**VARIANCE TO THE UNIFIED DEVELOPMENT CODE (UDC)
APPLICATION**

Address or Legal Description: 8845 Laurel Ln
Lot(s): 1 Block(s): D Subdivision Name: Creekview Ph. 11

**FENCE PERMIT APPLICATION**
Community Development Department
DEVELOPMENT SERVICES DIVISION

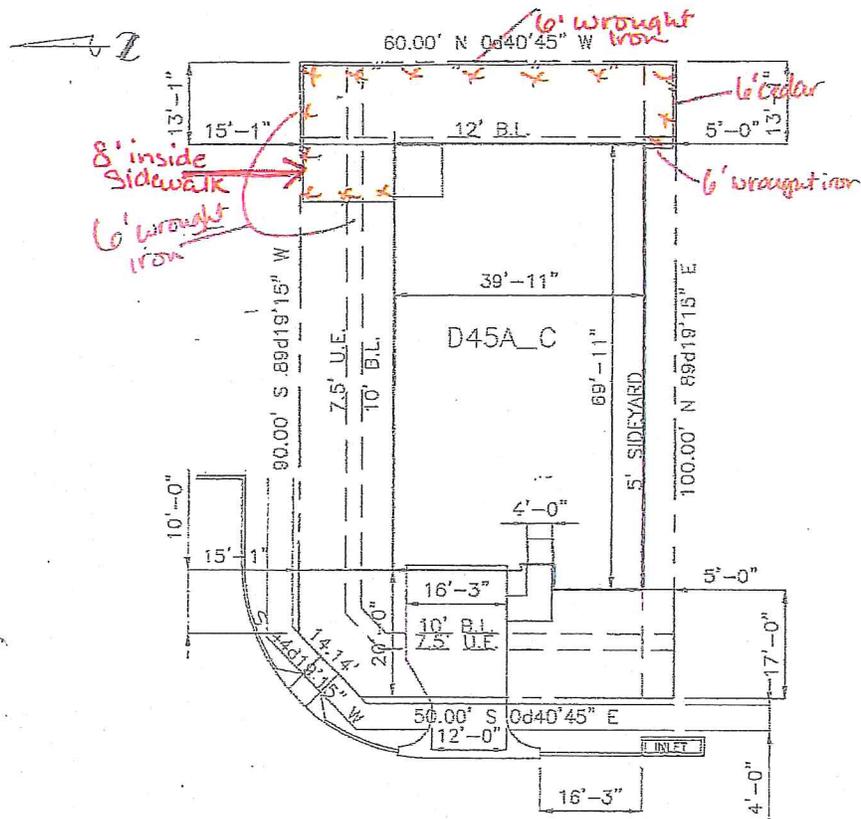
Fence on corner lot - adjacent to street shall be a minimum of 8' away from the sidewalk.... measured from the inside of the sidewalk
